36-2024 ADDENDUM 1

NORTH END SEWAGE TREATMENT PLANT (NEWPCC) DIGESTER TANK 9-14 SPIRAL HEAT EXCHANGER REPLACEMENTS

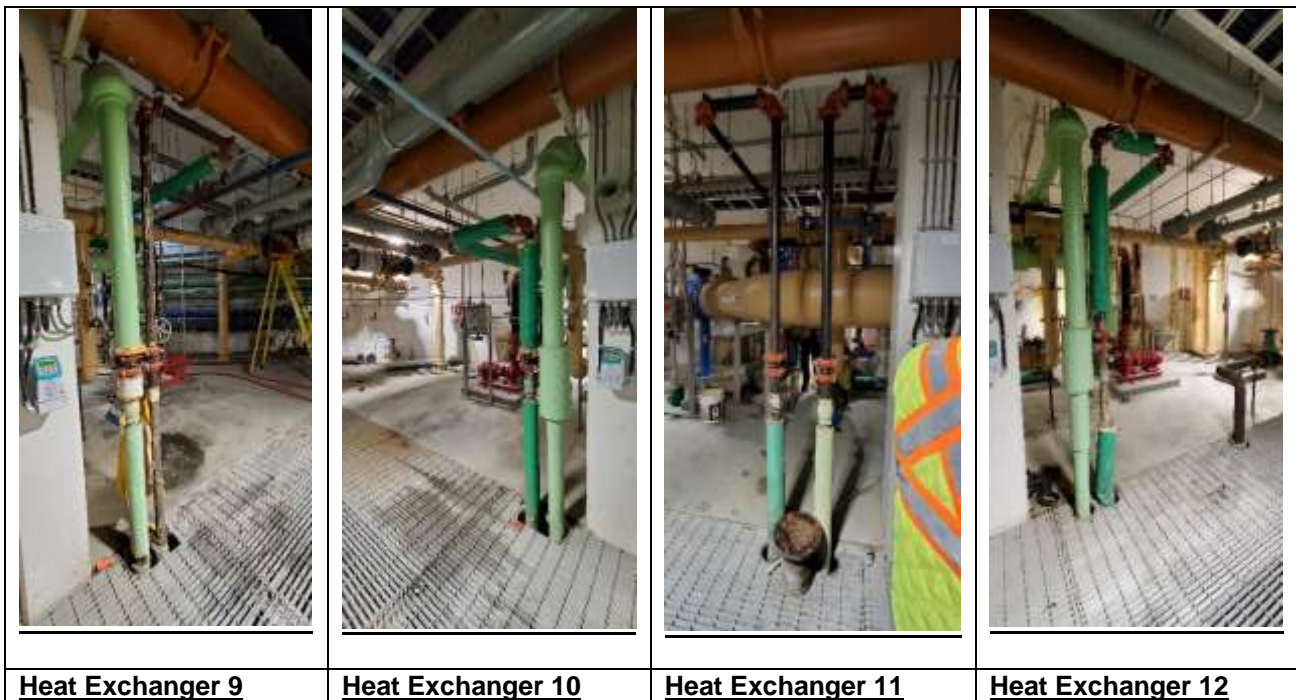
Q8: A housekeeping pad was noted to have a minor crack where one pedestal was attached. Should this pad be repaired or replaced?

A8: No repair or replacement should be necessary unless a serious defect in the substrate is discovered during the course of the work, which must be addressed through the standard PCN and Change Order process.
